Application for Variation of an Environmental Permit

Environmental Review Report (ERR) for
Application for Variation to the Environmental
Permit

China Harbour Engineering Company Limited

June 2026

Location of Emission Sources under Future Scenario

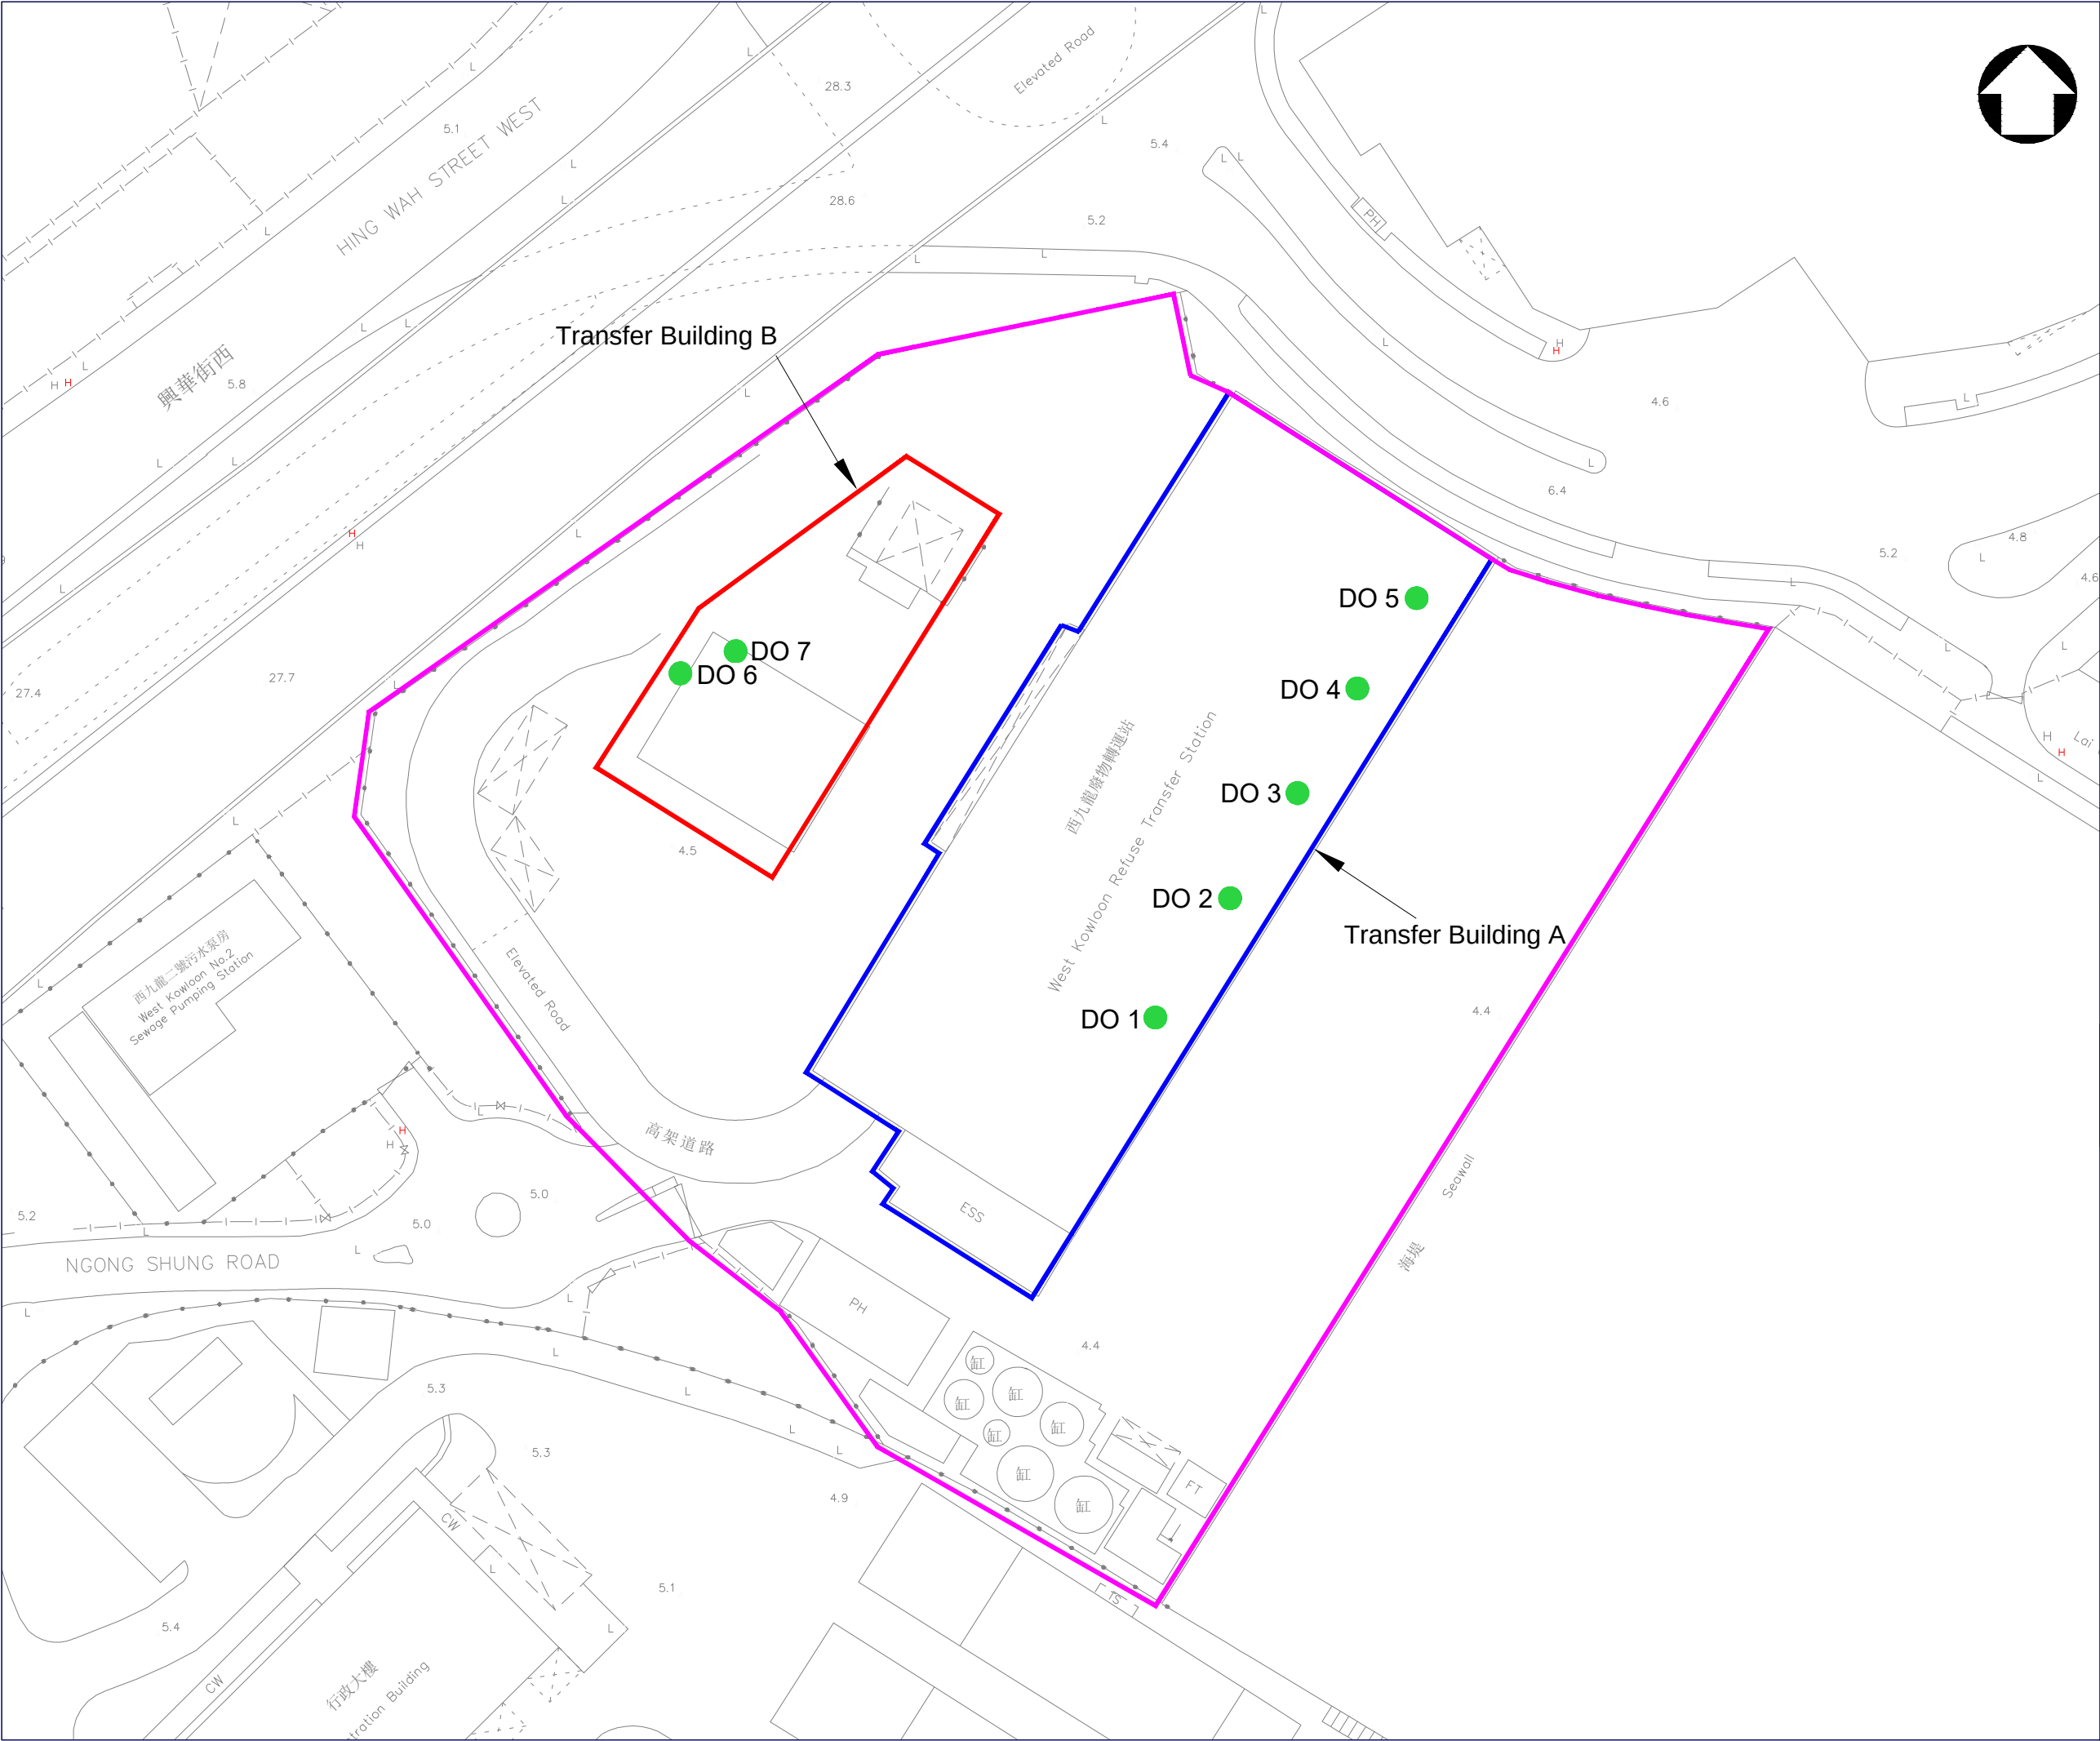
- 3.4.11. Under the Existing Scenario, there are five existing air/odour emission exhausts DO1 to DO5 located at TBA as shown in **Figure 3.2**, whilst there are two additional proposed emission exhausts DO 6 and DO7 in TBB as shown in **Figure 3.3**. Compared to the Existing Scenario, all of the representative ASRs remain the same distance from the closest emission exhausts under the Proposed scenario except for ASR6, for which the closest distance is shortened from 369m to 321m (i.e. due to the proposed exhaust DO6). Nevertheless, the additional exhausts are still more than 320 metres from ASR6. See **Table 3-5** below.

- 3.4.21. With the unloading and screening operations undertaken in a sealed system that is maintained under negative pressure, odour emissions arising from the delivery, unloading and treatment of GTW will be effectively alleviated. All air extracted from the GTWTF will pass through the odour control system consisting of two two-stage air scrubbers designed to remove H₂S and NH₃ before discharging to the atmosphere via two separate vents (DO6, DO7) at the roof of TBB.

- 3.4.22. The historical monitoring data for the existing air scrubbers at TBA from July 2023 to September 2025 has been reviewed in **Appendix C**. The historical data showed that the H₂S and NH₃ average outlet concentrations were all below 0.05 ppm and 0.5 ppm respectively.
- 3.4.23. Based on the above design requirement, the maximum outlet concentration at the scrubber exhaust is 0.05ppm for H₂S and 0.5 ppm for NH₃ respectively. See **Table 3-7** below for details. The location of the air emission outlets at TBB is shown in **Figure 3.3**.

- 3.4.26. For the Future Scenario, all seven air scrubber units (DO1 to DO5 at TBA, DO6 to DO7 at TBB) will be 2-stage units that remove both H₂S and NH₃. For the worst-case assumption, they will be modelled to operate at the same time with the maximum design outlet concentration of 0.05 ppm and 0.5 ppm for H₂S and NH₃ respectively.
